City of Santa Barbara
Planning Division

Memorandum

DATE: October 5, 2010
TO: Planning Commission
FROM: Danny Kato, Senior Planner *DJK*
 Daniel Gullett, Associate Planner *DG*
SUBJECT: Continuation of 3626 San Remo Dr. Subdivision (MST2009-00325)

REPORT DATE: August 23, 2010
AGENDA DATE: September 2, 2010
PROJECT ADDRESS: 3626 San Remo Drive (MST2009-00325)
Madsen Subdivision
TO: Planning Commission
FROM: Planning Division, (805) 564-5470
Danny Kato, Senior Planner *DJK*
Daniel Gullett, Associate Planner *DG*

MST 2009-00325 TENTATIVE MAP SAN REMO SUBDIVISION

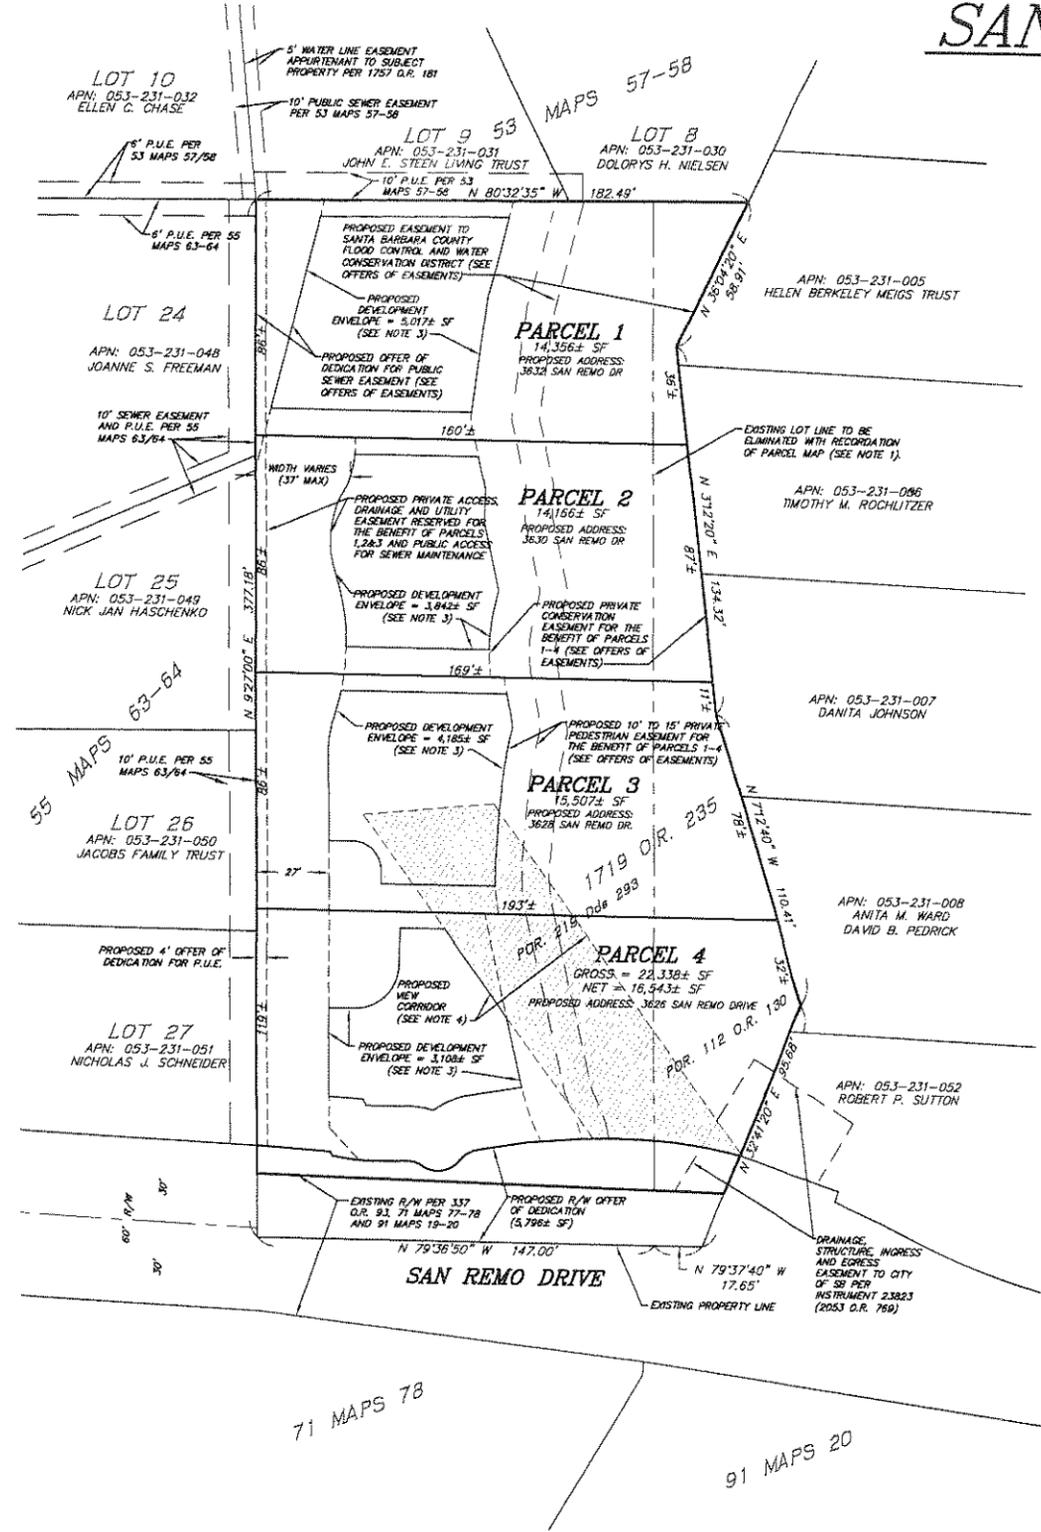
Staff does not believe that the proposed 40 foot creek setback is adequate for this location, and continues to recommend a 50 foot creek setback for all four parcels except at the location of the footprint of the existing main residence. The recommended greater creek setback is reflected in Condition C.1 of the attached conditions of approval.

2. **San Roque Creek Setback.** *The Conservation Easement referenced on TMI shall be expanded to include the entire area within 50 feet of the top of the western bank of San Roque Creek, with the exception of the footprint of the existing historically-significant building on Parcel 3. The development envelopes shall be reconfigured to be located outside the reconfigured Conservation Easement. ~~The added conservation area shall be included in the Restoration Area described in the Mitigation Monitoring and Reporting Plan prepared by Althouse and Meade, Inc., revised dated May 27, 2010, shall be revised to include the expanded conservation area. The revised Mitigation Monitoring and Reporting Plan shall be subject to the review and approval of the City Creeks Division and the resultant landscape plan shall be subject to review by the SFDB. The development envelopes shall be reconfigured to be located outside the Conservation Easement.~~*

2. **San Roque Creek Setback.** The Conservation Easement referenced on TMI shall be expanded to include the entire area within 50 feet of the top of the western bank of San Roque Creek, with the exception of the footprint of the existing historically-significant building on Parcel 3. The Mitigation Monitoring and Reporting Plan prepared by Althouse and Meade, Inc., dated May 27, 2010, shall be revised to include the expanded conservation area. The revised Mitigation Monitoring and Reporting Plan shall be subject to the review and approval of the City Creeks Division and the resultant landscape plan shall be subject to review by the SFDB.

1. Ms. Madsen is willing to increase the creek setback from the proposed 35 feet on Lots 1, 2, and 4 to 40 feet. This comes closer to the staff recommendation, but still preserves a reasonably sized building envelope on these lots. As noted in the Planning Commission hearing, one of the benefits of having a slightly larger development envelope is that it creates design flexibility. For example, an envelope that allows for a larger footprint also allows the home designer to minimize the square footage on a second story. Smaller massing on the second story helps to preserve privacy for adjacent neighbors. The proposed 40 foot setback is consistent with or larger than many recent Commission approvals. Please note that the 35 foot setback would remain on Lot 3 to allow for the preservation of the historic facade.
